PLANNING AND ZONING BOARD STAFF REPORT

109 SE 5th Avenue

Meeting	File No.	Application Type
January 26, 2026	2024-104	Level 3 Site Plan
Property Owner		Authorized Agent

Consideration of a Level 3 Site Plan Application with Architectural Elevations and Landscape Plan for a four-story, approximately 98,000 square foot, 26-unit multi-family residential development.

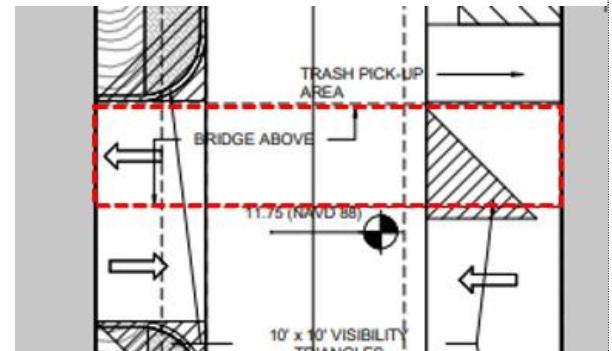
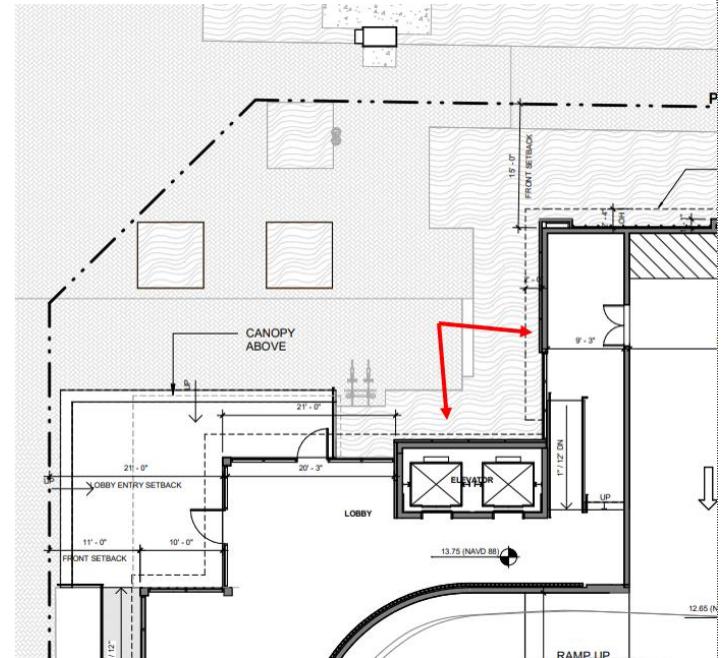
That being said, there are issues with the execution of the ground floor design that are detrimental to the quality of the public realm. Specifically, there is absence of a quality active use on the ground floor adjacent to the required civic open space at the NW corner. Principles of urban design require that for public spaces to be utilized to their fullest potential, it is essential that these spaces are lined with active uses within the adjacent structures so that there is an integration between the public realm and private space, where activity is naturally drawn through the public space which encourages further use, and to reinforce the idea of “eyes on the street” which facilitates safer and more vibrant public environments. LDR Section 4.4.13(G) provides specific regulations to ensure the civic space is presented with appropriate qualitative and schematic characteristics to achieve the desired outcome.

The applicant proposes a problematic ground floor configuration that undermines the purpose of the civic space and is inconsistent with quality urban design. The schematic choices are entirely avoidable, and despite Staff raising concerns from the initial review of this application, the Applicant has been reluctant to make modifications to the ground floor orientation and use-mix to help alleviate these crucial shortcomings.

Rather than lining the civic space with prominent and active uses, the building orients passive elements of the structure – such as the elevator stack and a secondary corridor that leads to the parking area – which are ill-suited to achieve the level of activity generation necessary for high quality public spaces. Best-in-class versions of public space will be lined by residential unit entrances; lobbies with multiple points of ingress/egress; commercial uses such as retail, café, and restaurant; or amenities that can function as gathering places, such as shared workspaces, coffee shops, etc. These types of uses accentuate the urban form by catalyzing the level of activity necessary to incentive use of the adjacent exterior space, as well as instill characteristics that strengthen the foundation of the neighborhood. Staff is concerned that, because of the lack of an active use liner, the required civic space will be an underutilized and inactivated aspect of the public realm.

Specifically, LDR Section 4.4.13(G)(3)(d) states that *Civic open spaces shall be lined by building facades or streets on all sides. In order to provide oversight of the space, buildings facing civic open spaces shall contain active uses.* While the required civic space is lined by extended lobby area, which technically may qualify as part of an active use (Main building lobby), the specific design and configuration of the portion of the lobby that lines the civic space is deficient for the reasons stated previously. Staff encourages the Board to consider whether the qualitative aspects of the ground floor design sufficiently meet the intent of the Central Business District, or if conditions that require revisions to the configuration to better address the referenced concern are appropriate.
